From: drainage <drainage@midsussex.gov.uk>
Sent: 10 January 2025 17:31:24 UTC+00:00
To: "Stefan Galyas" <Stefan.Galyas@midsussex.gov.uk>
Cc: "drainage" <drainage@midsussex.gov.uk>
Subject: 2025.01.10 Re: DM/24/3107 - 83 Cuckfield Road Hurstpierpoint Hassocks West Sussex BN6 9RR

The Flood Risk and Drainage Team have reviewed the information submitted in support of this application and can provide the following comments.

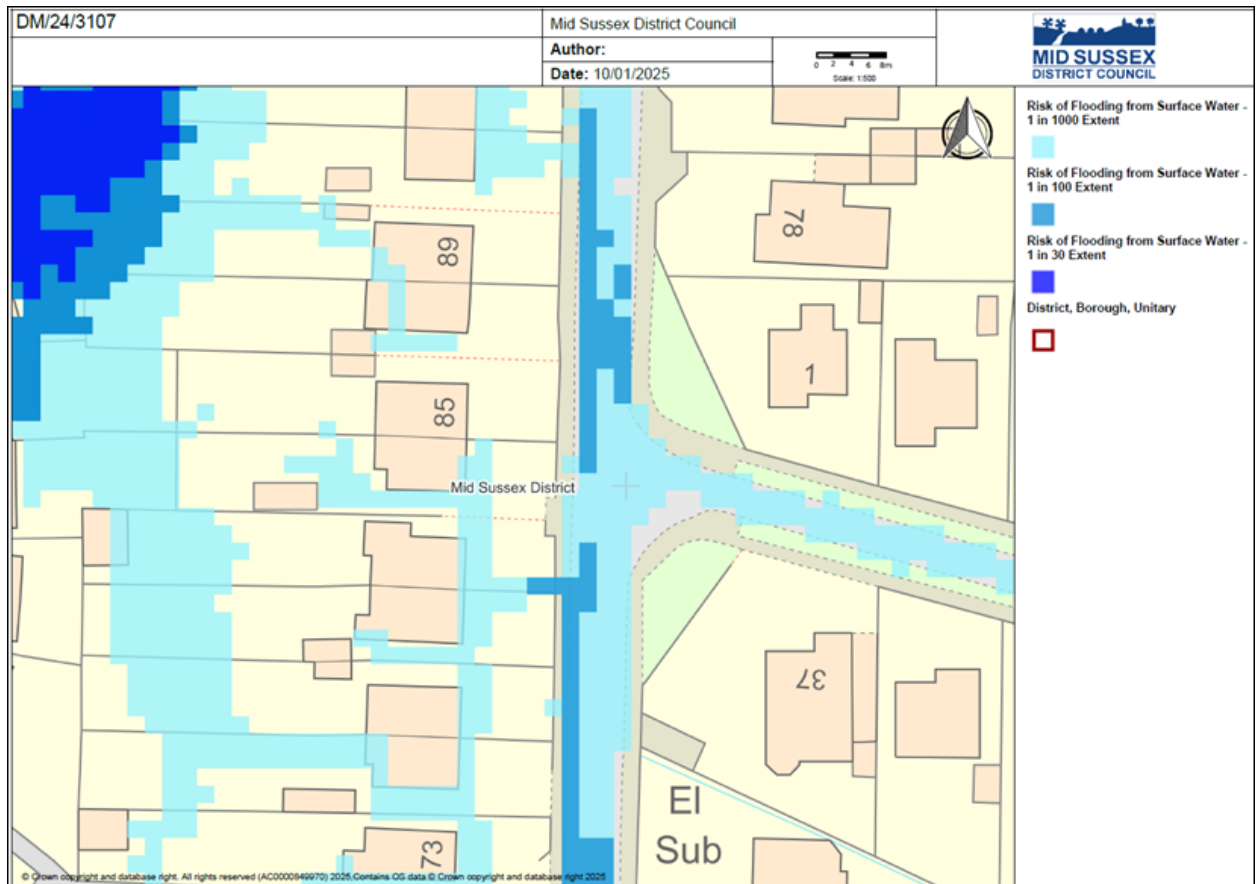
The proposed development site is located within an area impacted by the Low surface water flood risk (1:1,000 flood event). Following the approach set out under the NPPF for assessing fluvial flood risk (flood zones) this area would be considered consistent with Flood Zone 2 (1:1000 extent).

In line with the Environment Agency's standing advice for minor extensions it is recommended finished floor levels are raised 300mm above the estimated 1:1000 surface water flood depth (which is the proxy for the 1:100+CC). If it is not possible to raise the finished floor levels to the required height, you will also need to include extra flood resistance and resilience measures. These measures should protect the property to at least 600mm above the estimated flood depth. Only use resistance measures that will not cause structural stability issues during flooding. It may not be possible to safely exclude the full estimated flood depth. If this is the case, you will need to exclude it to the structural limit then allow additional water to flow through the property.
